**ITEM #4: For the ARCHITECTURAL COMMISSION on MONDAY, March 16, 2015 @ 7:00 P.M.**

**REQUEST:** Consideration of modifications to the approved elevations for Building 1 in the Long Grove Commons PUD for the for the “Primrose School” submitted by Mr. John Finnemore

ORIGINAL SUBMITTAL

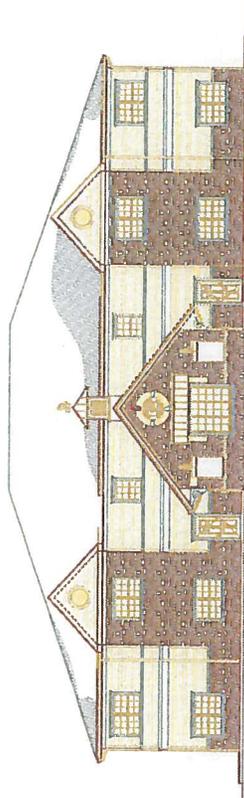
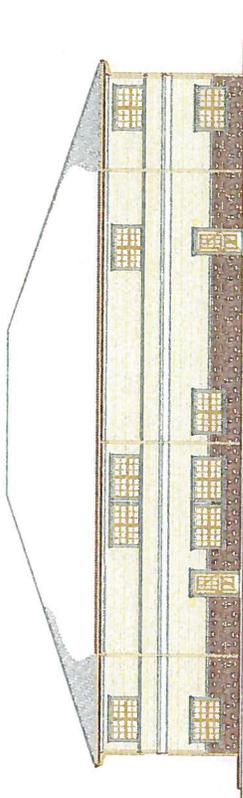
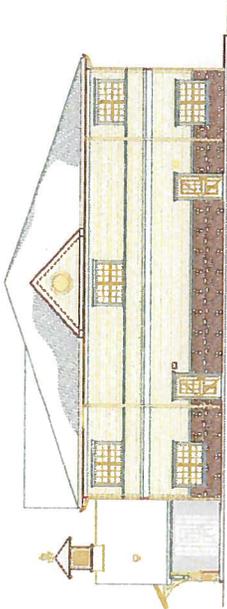
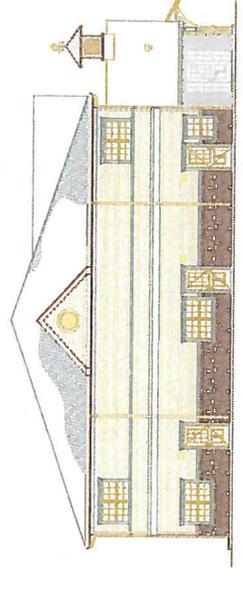
**UPDATE -** *At the December meeting the AC initially discussed this proposal. At that meeting the AC noted concerns with the proposed structure and offered the following suggestions or remedy those concerns;*

- *Elements of the “Long Grove Style” should be better incorporated into the structure;*
- *More contrast should be added to the color scheme of the building;*
- *Elevations should incorporate more of the architectural details found in the existing structures in Long Grove Commons;*
- *A fencing detail should be provided;*
- *A final landscaping plan should be provided;*
- *Revisions to be presented to the AC at the February 9<sup>th</sup> meeting (11” x 17” format).*

*To that end the petitioner has submitted revised elevations for consideration by the AC which are attached. Fencing detail, a final landscape plan and play ground equipment details are also included for AC consideration.*

1ST REVISION

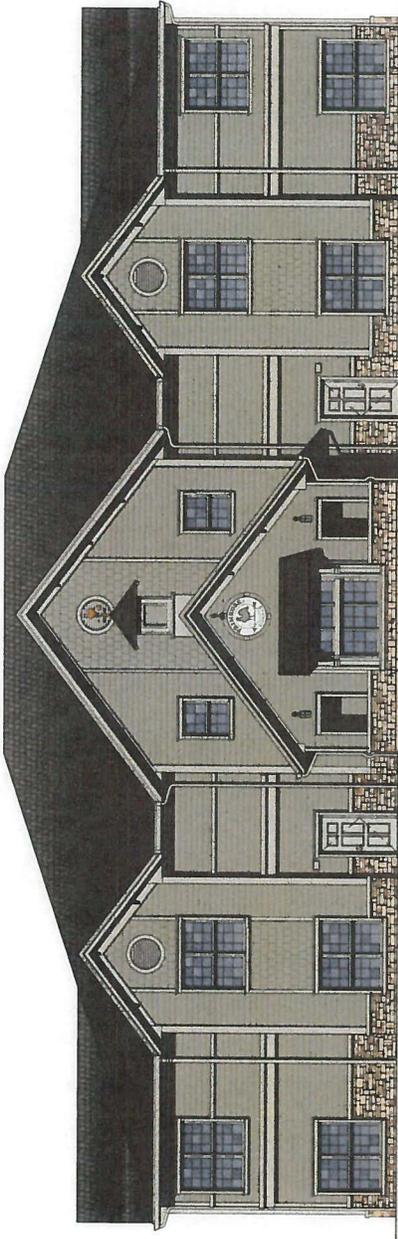
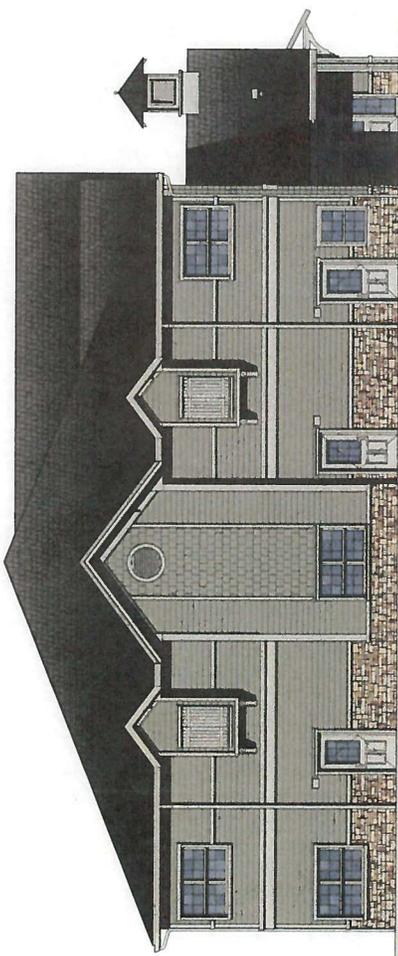
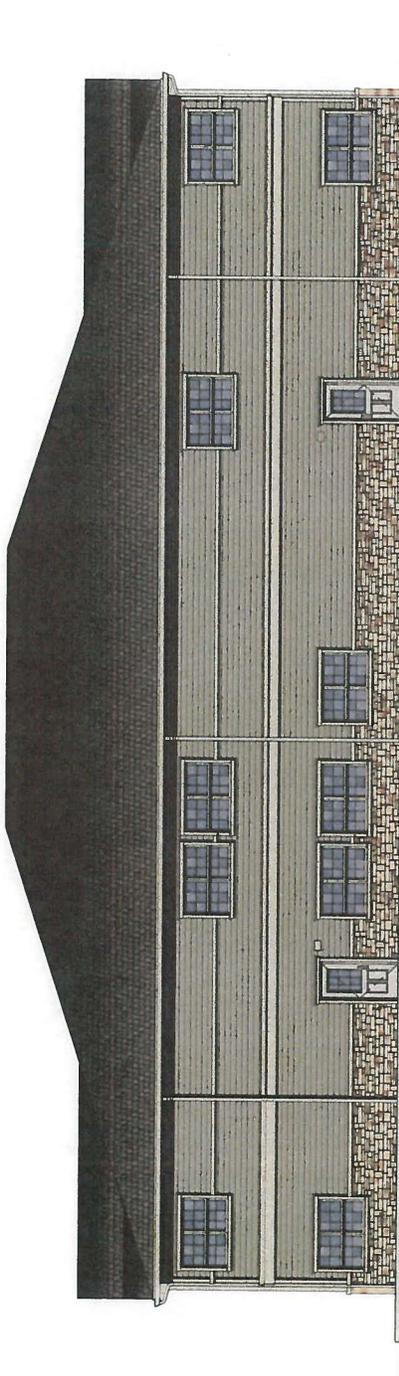
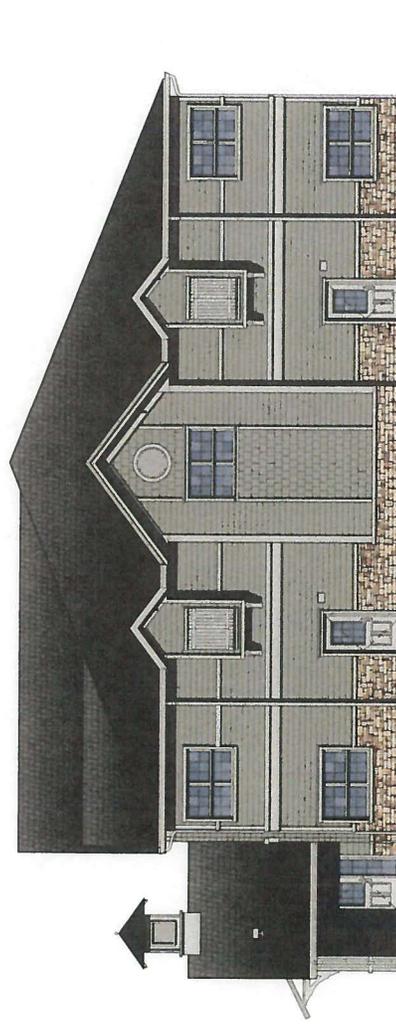
**2<sup>nd</sup> UPDATE -** *At the February meeting the AC revisited this proposal. At that meeting the AC again noted concerns with the proposed structure and offered the following suggestions or remedy those concerns;*

- *Provide further articulation of the structure to reduce the scale of the structure to provide more of a residential look;*
- *Articulate trim board around the structure;*
- *Project dormers down the north and south side of the building (to break-up window lines);*
- *Revised elevations shall identify building lighting including fixture details and photometrics (if possible).*

*The petitioner has again submitted revised elevations for consideration by the AC which address the concerns raised by the AC and are attached.*
